Technical Service Bulletin

Chain Sliders for 2017 50's and 2016 FWE
TSB1717

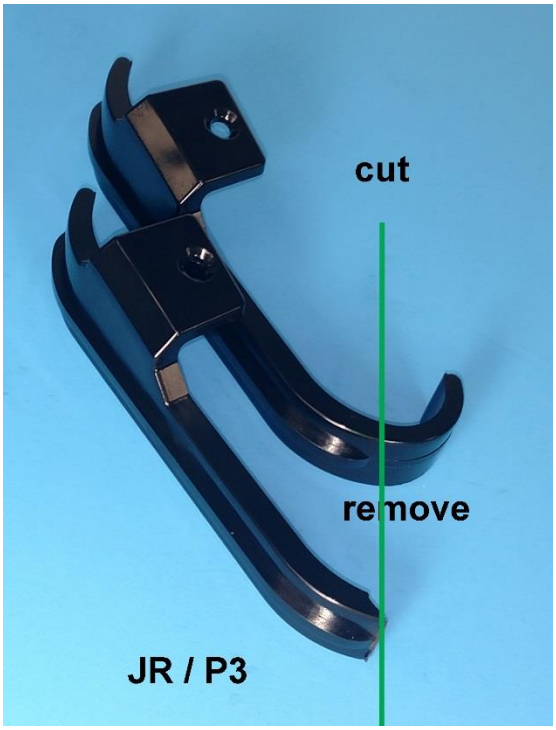
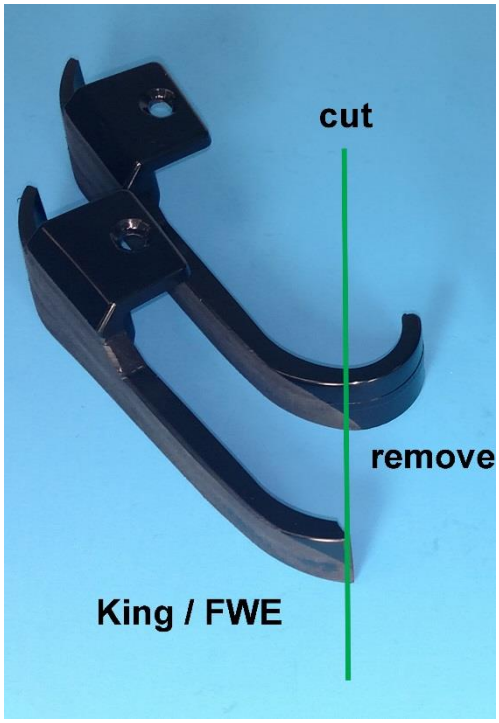
To avoid the chance of the front sprocket catching the chain slider, improvements, as shown below, have been made effective March 31, 2017.

GCMU0040 and GCMU0033 ordered from March 31, 2017 and forward will have the modifications as shown below.

For owners of 2017 CX50 P3/JR/King/FWE or 2016 CX50 FWE, we advise that you remove your chain slider and trim per the picture below.
